**City of Portland, Maine – Building or Use Permit Application** 389 Congress Street, 04101, Tel: (207) 874-8703, FAX: 874-8716

Location of Construction: Lot #7 Buca Run 04103 #40		Owner: ** Craig Holman		Phone: 892-4847		Permit No: <b>000519</b>	
Owner Address: *** 38 Chute Rd. Windham 04062		Lessee/Buyer's Name:		Phone:		BusinessName:	
Contractor Name: Owner/Holman Development, Inc.		Address: N/A		Phone: N/A		Permit Issued:  MAY 18	
Past Use: Vacant		Proposed Use: Single Family W/Attached Garage		COST OF WORK: \$ 80,000.00		PERMIT FEE: \$ 504.00	
				FIRE DEPT. <input type="checkbox"/> Approved <input type="checkbox"/> Denied		INSPECTION: Use Group: A-3 Type 5B BOCA 99 Signature: <i>[Signature]</i>	
Proposed Project Description:  Construct a new Single Family w/Attached Garage				PEDESTRIAN ACTIVITIES DISTRICT (P.A.D.)		Zone: <b>R-2</b> CBL: 336-H-057	
				Action: Approved <input type="checkbox"/> Approved with Conditions: <input type="checkbox"/> Denied <input type="checkbox"/>		Zoning Approval: <i>[Signature]</i> with conditions 5/18/00 Special Zone or Reviews: <i>[Signature]</i>

BUILDING PERMIT REPORT

**CITY OF PORTLAND, ME  
BOCA 1999 Plan Review Record  
One and Two Famil

25'-0 3/4" x 32'-0"  
REVERSED WINTERPORT CAPE  
**FOUNDATION PLAN**

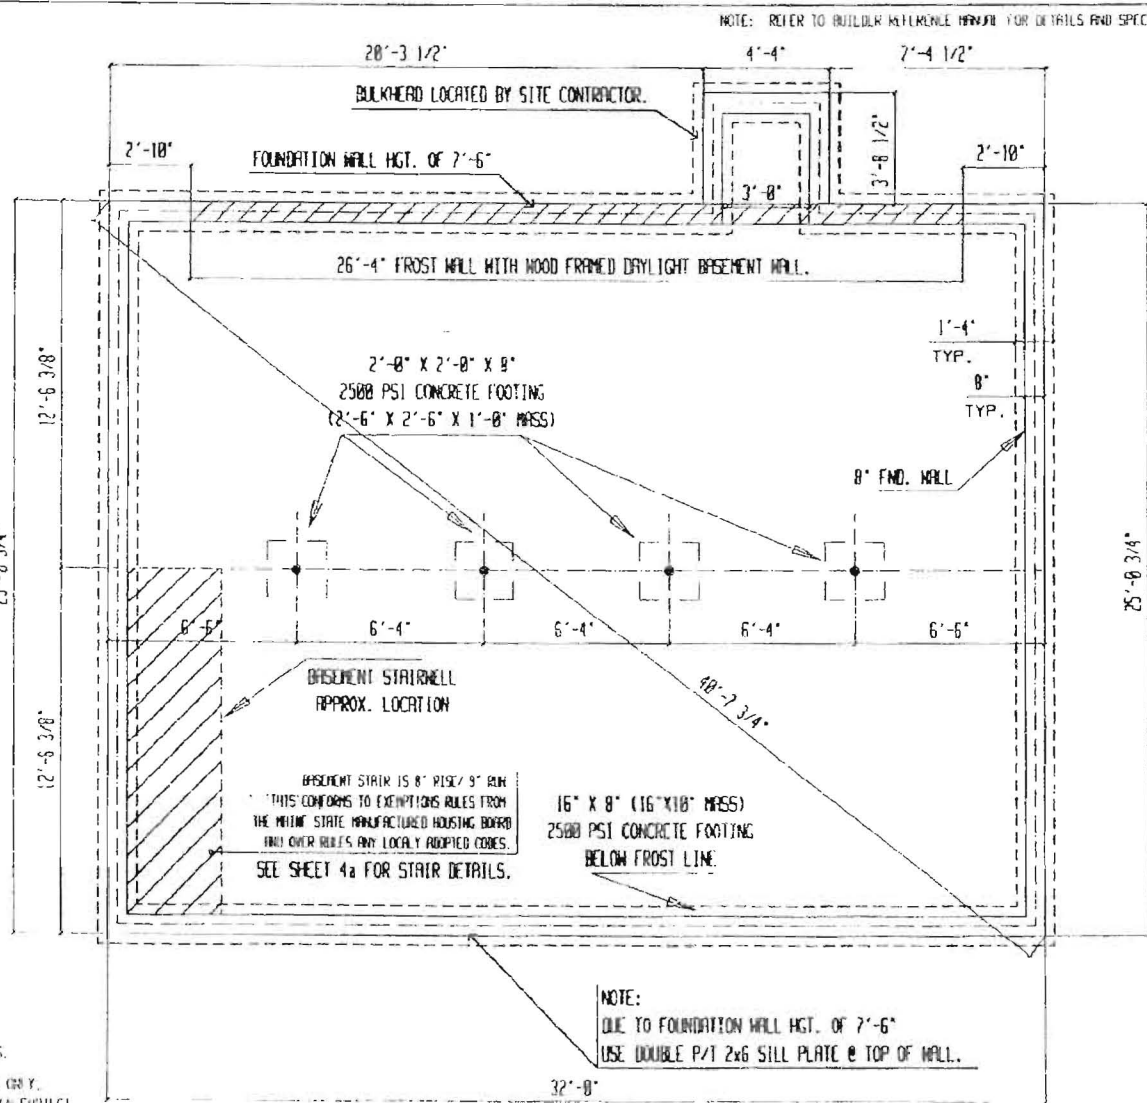
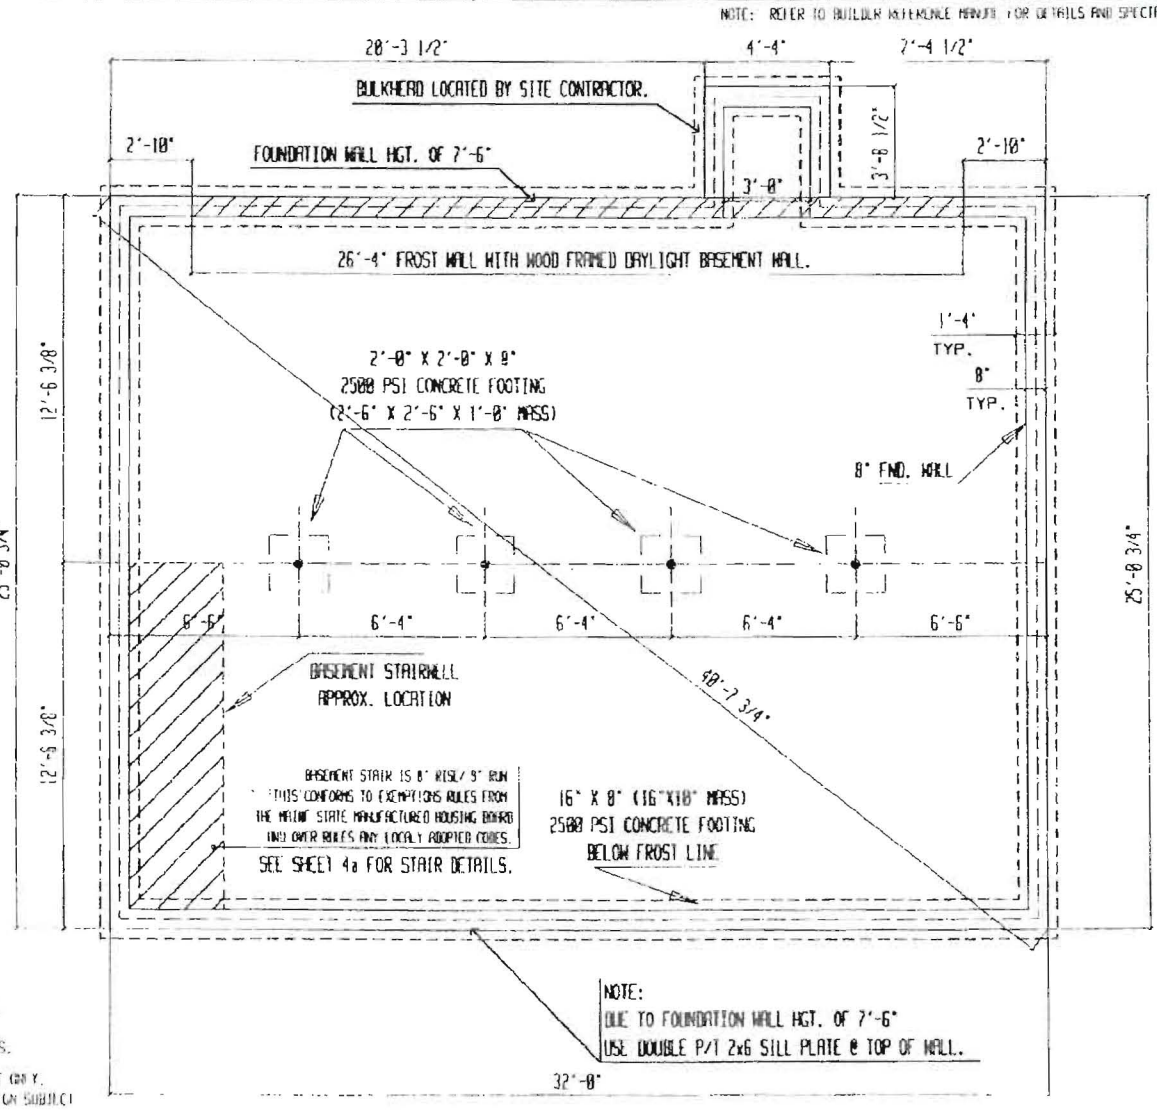
- ① SIZE OF HOUSE IS REDUCED BY 11".
- ② NO GARAGE WILL BE BUILT.
- ③ FRONT PORCH WILL NOT BE BUILT.  
- PREFORMED FRONT STAIR WILL BE SET.
- ④ NO BACK DECK WILL BE BUILT.
- ⑤ BILCO WILL BE MOVED TO RIGHT REAR OF HS.

SHEET NO.  
8-STR

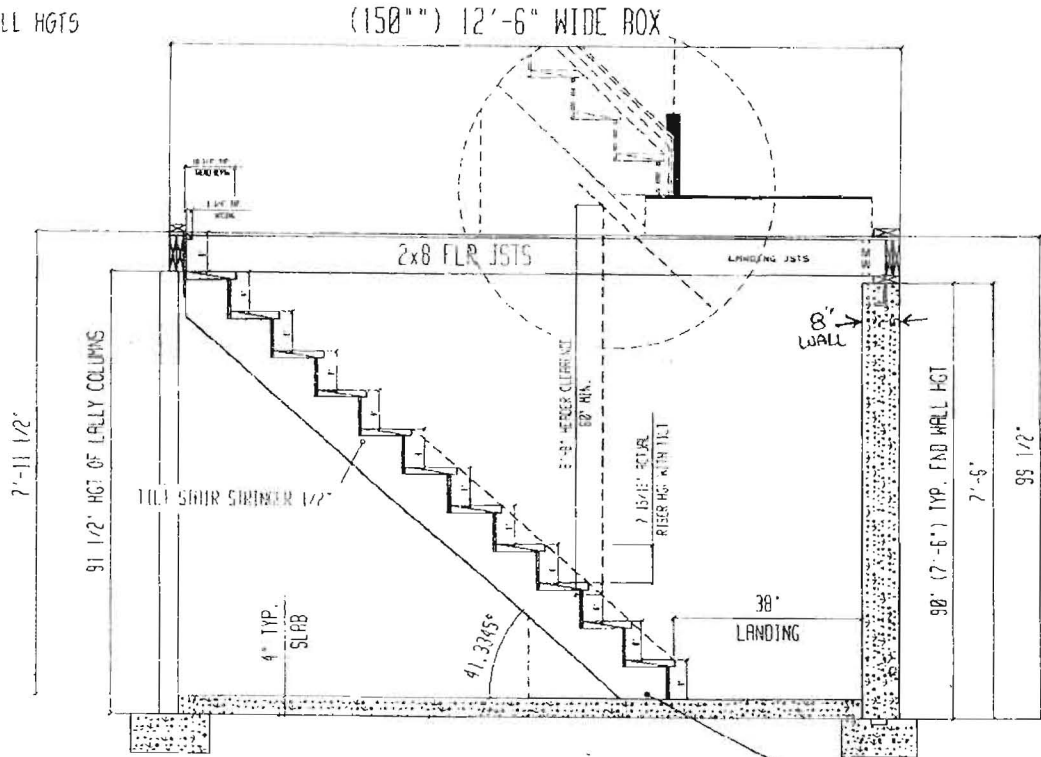
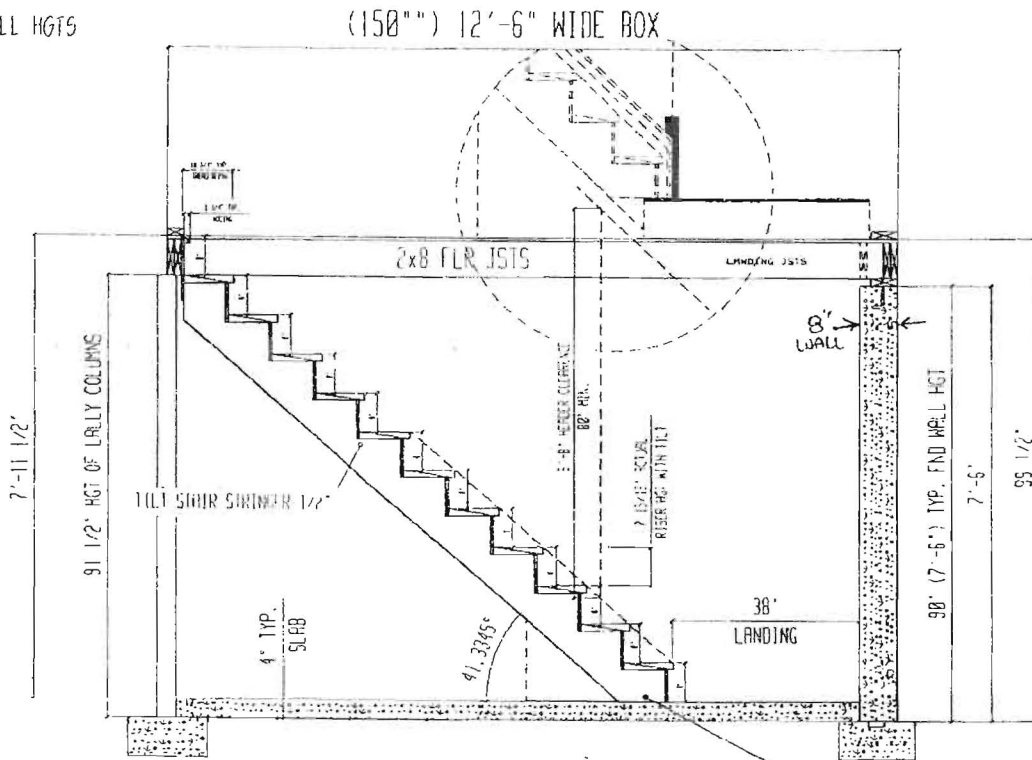
1/23/01 Final C.O. inspection - exterior steps/pails ok, need guardrail on basement stairs & Heating Appliance permit. JB

2/8/01 Final - wall & handrail installed in basement, Permit submitted for Heating JB C.O. Manufactured Housing Board No. 18638
